Sydney Cricket Ground Stage 2—MA Noble/Bradman Redevelopment Proposed by Sydney Cricket and Sports Ground Trust

MP08_0103 Section 75(w) Amendment—Heritage Impact Assessment

Drawing Title
ROOF PLAN
Drawing Number
D-07A - COMPARISON
Date
SEPT-2011

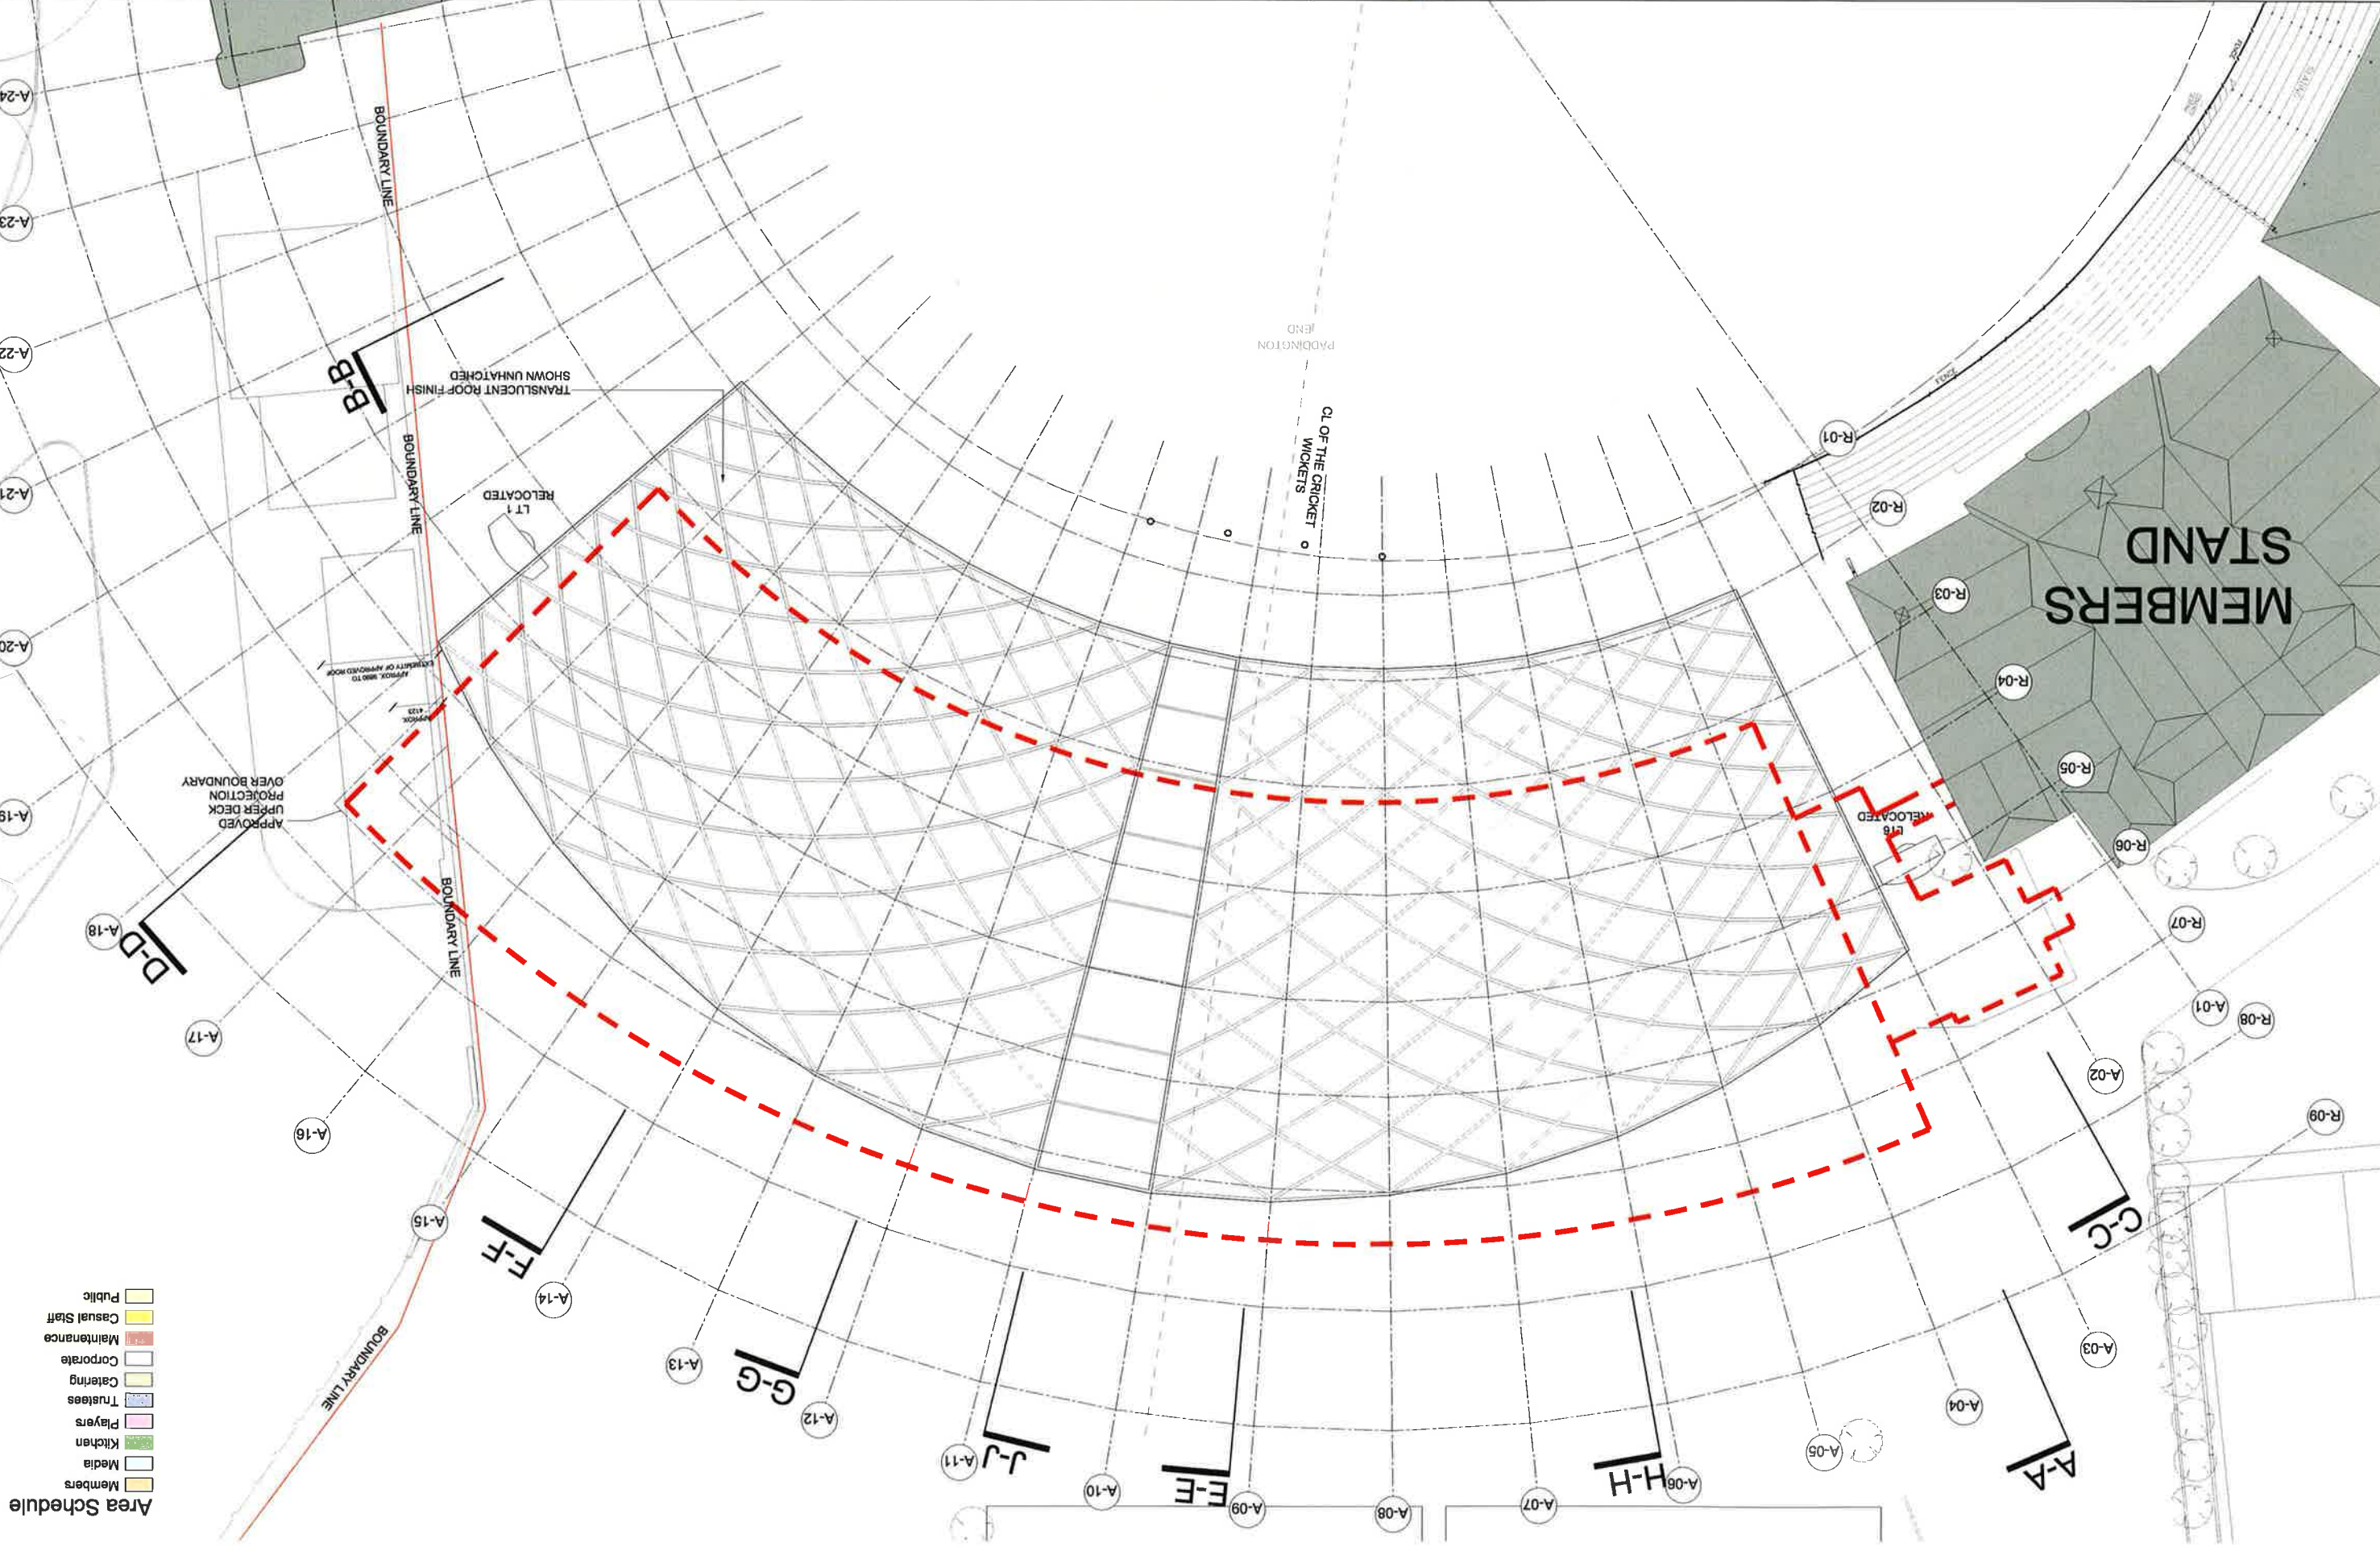
New grandstand higher than the existing Noble and Bradman Stands and significantly higher than Members' Stand.	The leading edge of the roof will be 2.77m higher than that of the previously approved roof. The rear edge of the roof falls from the centre towards each end. The highest point of the roof will be 5.3m higher than the rear of the roof of the approved stand.	The additional height will add significantly to the contrast between the heritage stands, and the new stand, impacting the relationship between the stands.
SCG Oval		
Extension of oval by 3m to the north.	Extension of oval by 3m to the north.	No additional impact.
Bradman Stand and Groundsman's Workshops		
Demolition of the Bradman Stand (Moderate) and Groundsman's workshops (Moderate).	Demolition of the Bradman Stand and the Groundsman's workshops.	No additional impact.
Archival recording and salvage of elements recommended.	Archival recording at a level consistent with its Moderate heritage value and salvage of elements such as plaques and memorabilia for the museum.	No additional impact.

Views provided to the east elevation of the Members' Stand from other stands to the east mitigated through the setback of the new roof.	New roof design is more open and transparent but is significantly forward of the approved scheme. It is designed to be read in two parts as a strategy to "pavilionise" the stand roofs, rather than unite them as a partial circle.	Open design of the new roof will provide opportunities for views from the other stands to the east through the upper stand structure. However its increased height and forward roof thrust will increase the contrast between the new stand and the Members and Ladies Stands.
More seating in the new grandstand to allow appreciation of the Members' and Ladies' stands.	No change to seat numbers.	No additional impacts.
Setting of Members and Ladies Stands		
Significant change in the view looking north and northwest from the oval and other grandstands from increase in scale, height and bulk of new stand, reducing views to the exterior .	Significant change in the view looking north and northwest from oval and other grandstands from further increase in scale, height and bulk of proposed stand. Open roof design will provide some views to exterior above seating tiers. Significant change of relationship to Members' Stand proposed via a glazed 2-storey link (yet to be detailed and subject to discussion with Heritage Council) which will close the opening between the new stand and the Members' Stand, impacting the views from the oval outwards. Change to the views looking south and southeast from the Members' entrance and Walk of Honour. The increased projection to the rear means that the new stand is not as readily perceptible as part of the suite of grandstand buildings around the oval, which—though varied in form and height—nevertheless articulated and reflected the essential shape of their function: that of spectator grandstands.	Additional impact of prominence of Western Tower form by the height, bulk, scale, and character of the new stand. Positive impact of new open partly transparent roof form which dips at either end at the rear towards its neighbouring stands. Additional impact on views from the oval and setting of Members' Stand from glazed link, closing external views. Views now impacted or terminated by new stand. The proposed rear extension of the Noble Stand will impact the ability to appreciate the oval form of the original arc or segment formed by the grouping of buildings around the oval. The incorporation of the service road within the new stand adds to the loss of perception of the oval enclosed by grandstands.
